Access Compliance Report

Public Rights-of-Way

(Curb Ramps)

Intersection ID: 25815	Main Street: REA_RD	Cross Street: PINEVILLE-MATTHEWS_RD	Location: SW
ADA ID: 66C90E5CD1F1	Ramp Type: IslandPerp	Initial Pass/Fail: Fail	Overall Compliance: No
Severity Score: 21.25			
Codes/Mitigation Info/Possible Solution		Field Measurements/Component Compliance

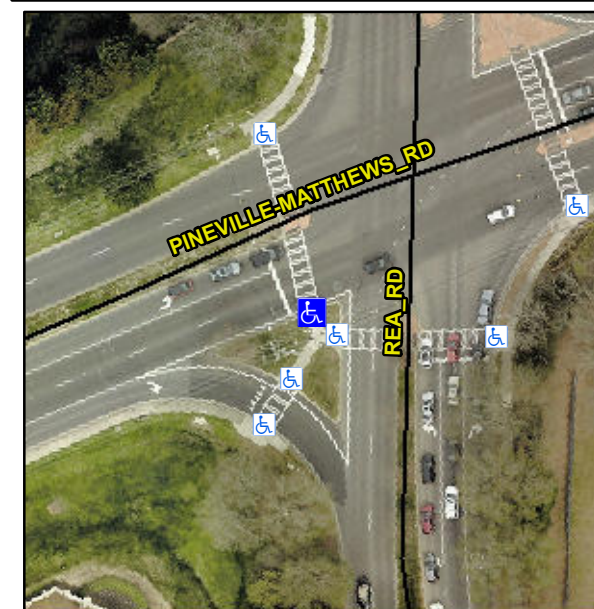
R304.5.1, R304.2.2

Compliance	Description	Data	Compliance	Description	Data
N/A	Ramp Length (in)	69.0	No	Ramp Slope (%)	8.5
No	Ramp Width (in)	47.5	Yes	Ramp XSlope (%)	1.1
N/A	Flare Type LT	N/A	N/A	Flare Type RT	N/A
N/A	Flare Slope LT (%)	N/A	N/A	Flare Slope RT (%)	N/A
N/A	Flare Traversable LT?	N/A	N/A	Flare Traversable RT?	N/A
N/A	Landing Length (in)	N/A	N/A	DWS Provided?	N/A
N/A	Landing Width (in)	N/A	N/A	DWS Contrast?	N/A
N/A	Landing Slope (%)	N/A	N/A	DWS Length (in)	N/A
N/A	Landing X Slope (%)	N/A	N/A	DWS Full Width?	N/A
N/A	Landing Curb? (Y/N)	N/A	N/A	DWS Offset (in)	N/A
N/A	Shared Landing?	N/A			
N/A	Gutter Ponding?	N/A	N/A	Gutter Slope (%)	N/A
N/A	Gutter Lip Ht (in)	N/A	N/A	Gutter X Slope (%)	N/A
N/A	Painted X Walk1?	Yes	N/A	Painted X Walk2?	N/A
	X Walk 1 Direction	To N		X Walk 2 Direction	N/A
N/A	X Walk 1 Width (in)	109.0	N/A	X Walk 2 Width (in)	N/A
	X Walk 1 Slope (%)	3.4		X Walk 2 Slope (%)	N/A
	X Walk 1 X Slope (%)	1.2		X Walk 2 X Slope (%)	N/A

Remove & Replace Entire Ramp.
